Department of Energy  
Albuquerque Operations  
Los Alamos Area Office  
Los Alamos, New Mexico 87544

Enclosed are the revised Part A. and the July 1, 1988 letter sent to you regarding increasing the storage capacity for hazardous waste at Los Alamos National Laboratory. The following changes occur in this Part A.

LOCATIONS OF TA-50  
CHEMICAL WASTE INCINERATOR AND  
CONTAINER STORAGE FACILITIES

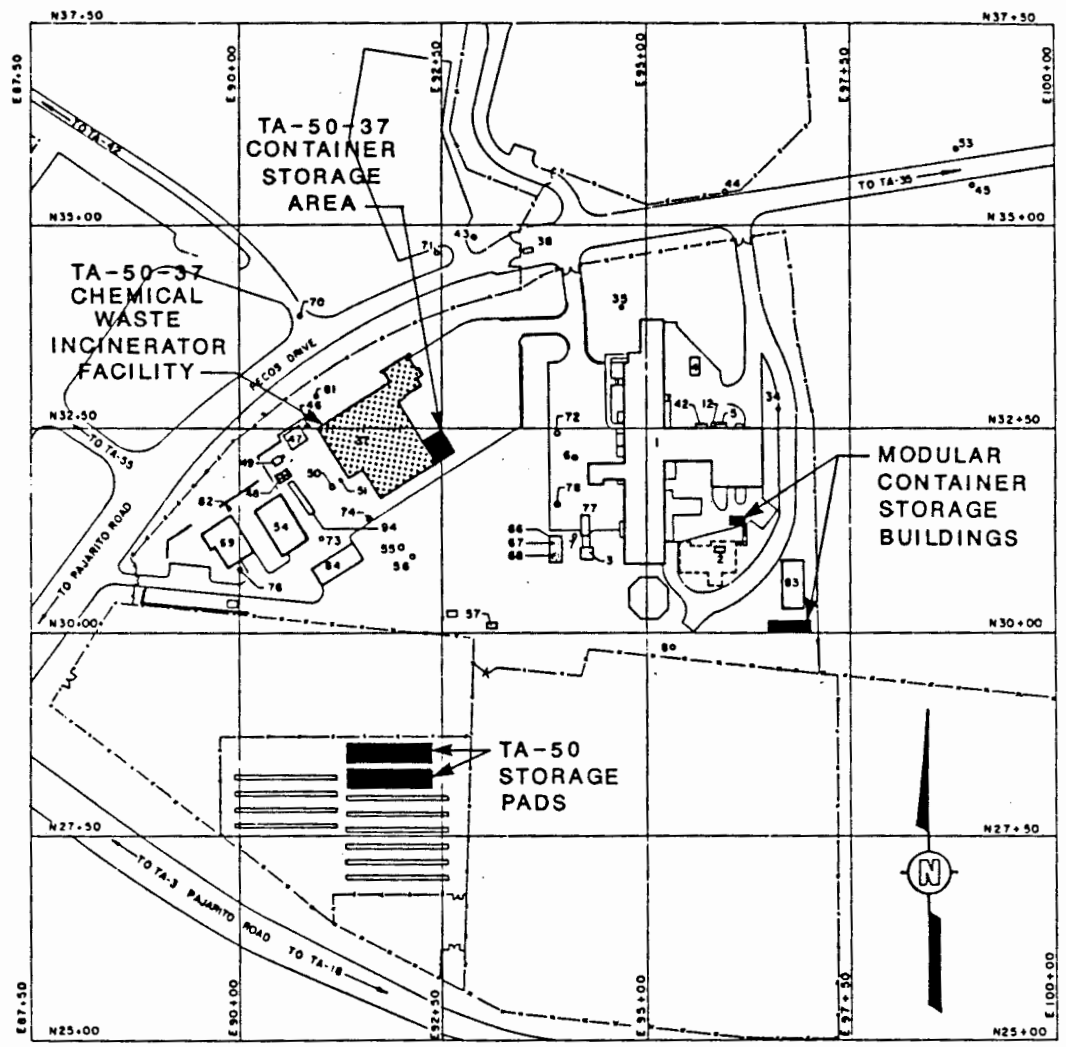
1. Page 1 of 5 on Form 3510-3, Line Number 1 - Storage process design capacity increased by 37,830 gallons to 275,820 gallons.
2. Revised figure "Locations of TA-50 Chemical Waste Incinerator and Container Storage Facilities" - Additional storage pad added.
3. Revised figure "TA-54 Area L Waste Management Facilities" - Designation of bermed area as liquid waste storage area.
